Report to Planning and Environment Committee

Subject: 2857082 Ontario Inc.
3510-3524 Colonel Talbot Road
Public Participation Meeting

Date: July 25, 2022

Figure 3 – Original Site Concept

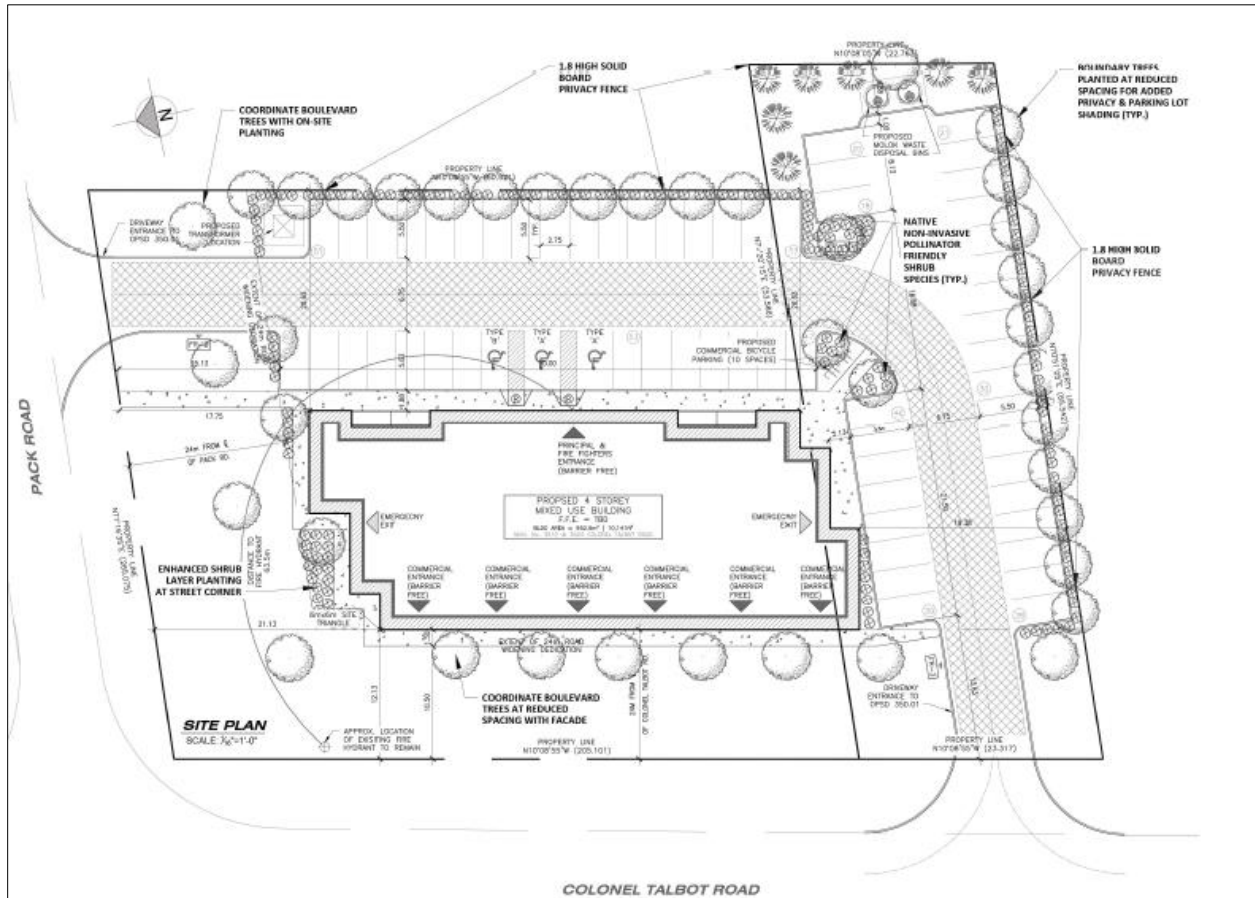
- i) Encourage the applicant to return to the Panel once the development is at the detailed design and site plan submission stage;
- ii) Relocate the transformer to a less prominent location away from the street frontage along Pack Road;

- iii) Ensure parking areas visible from the street are screened in order to reduce their visual impact along both streetscapes;
- iv) Provide safe and effective direct pedestrian linkages to Colonel Talbot Road and Pack Road from the building;

Comments from Urban Design staff highlighted various considerations:

- Provide safe and effective pedestrian linkages to Colonel Talbot Road and Pack Road.
 - Provide connections from the pedestrian walkway abutting the building with the road widening sidewalks and intersection for direct pedestrian access from the public sidewalk.

- Ensure the building is appropriately scaled and located on the site to provide visual interest and enclose the street.
 - Extend the building façade along the perimeter of both Colonel Talbot Road and Pack Road to have a more efficient use of land and foster an enclosed pedestrian-oriented streetscape.

Figure 8 - Revised Concept Plan (June 2022)

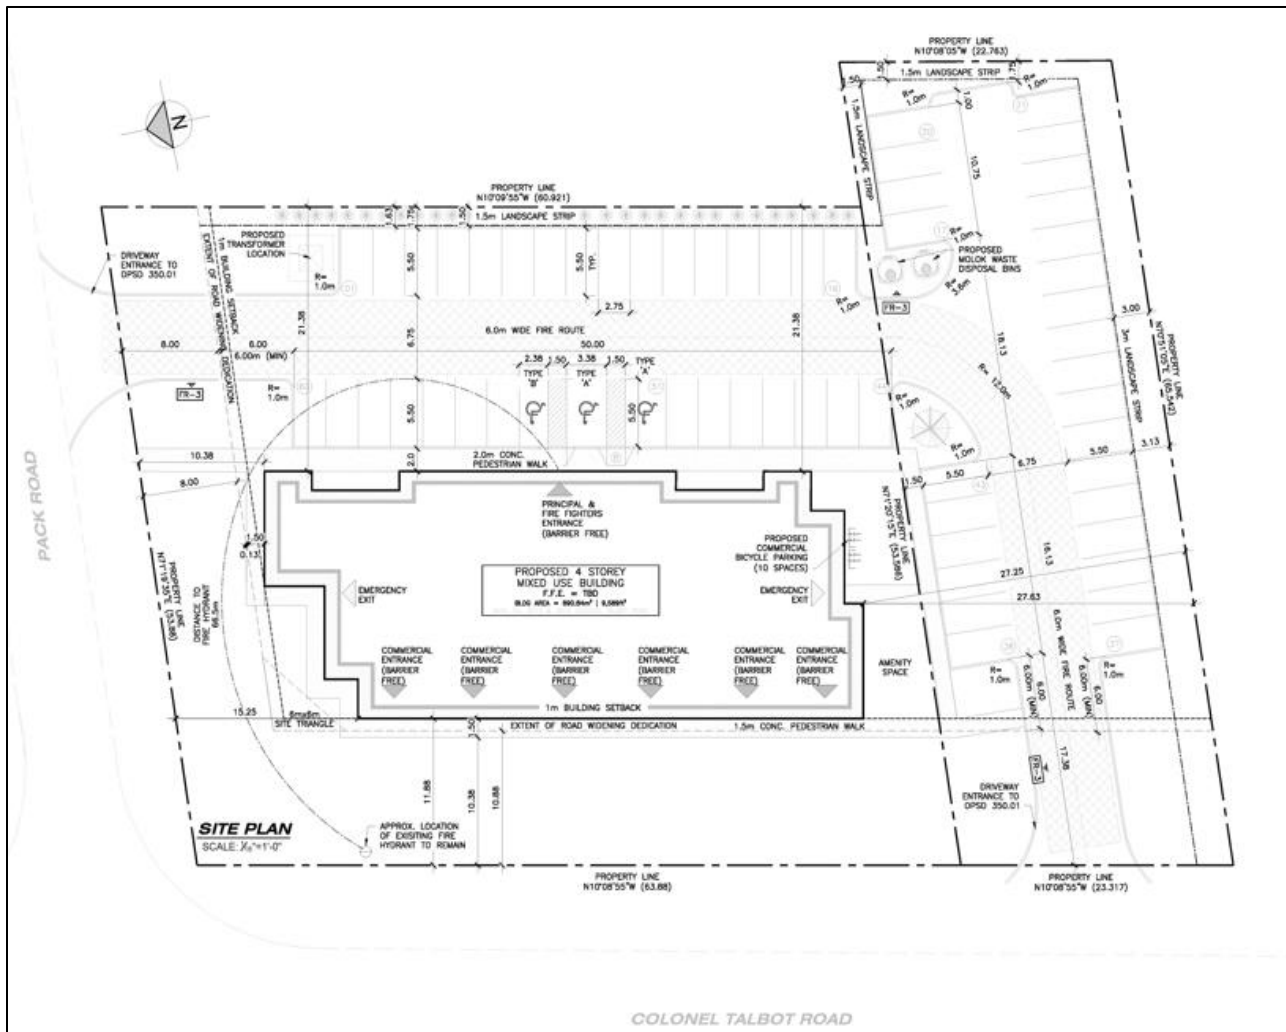
- The Panel notes that the setback to the surface parking lot along the South property line is insufficient and would require the removal of existing trees and landscape long this edge. The Panel is concerned that this would create an inefficient privacy buffer between the residential property to the South, as well as create unfavourable wind conditions. Consider reducing the building footprint and shifting the building to the North to retain the existing South tree line and provide an adequate landscape buffer.

Comments from site plan on the revised concept include the following:

- Long-term bicycle parking is required. Short-term bicycle parking should be located further forward on the site to service the commercial uses and on a hard surface.
- Setback for parking needs to be sufficient to allow for tree plantings, 3.0m is considered a minimum standard.
- Parking peninsulas should be included in accordance with the SPCBL with tree plantings both within the parking area and within the peninsulas already provided.
- The plan should anticipate the location of the future City sidewalk.
- As an apartment building a garbage room and put-out location should be provided.
- A communal amenity area for residents of the building located away from the City right-of-way is required.

Comment:
The Panel notes that the setback to the surface parking lot along the South property line is insufficient and would require the removal of existing trees and landscape long this edge. The Panel is concerned that this would create an inefficient privacy buffer between the residential property to the South, as well as create unfavourable wind conditions. Consider reducing the building footprint and shifting the building to the North to retain the existing South tree line and provide an adequate landscape buffer.

The parking area is located to the east and south of the building and does not extend into the exterior side yard beyond the building façade. Additional setbacks for the parking area along the southern property edge (3.0m) are recommended to ensure there is enough area to plant robust tree plantings, as per the landscape plan, and to protect trees/root zones located on the adjacent properties.

The proposed building setback from the south property line is 27.63m. The applicant is providing a 3.0m setback from the property line to the parking area along the south property line, to ensure robust plantings and trees can be accommodated as additional mitigation, as per the proposed landscape plan. The additional setback will also help to protect trees on the adjacent property by providing an adequate setback for the critical root zones. A 1.8m board on board fence is also proposed along the property line to further protect the adjacent property. No balconies are proposed along the southern building façade.

The Site Plan has been revised to extend the landscape strip along the south boundary limit to 3m. Further planting details may be reviewed at the Site Plan Control phase. The landscape strip is able to accommodate a privacy fence and planting, which would aid in reducing the perceived privacy and wind concerns.
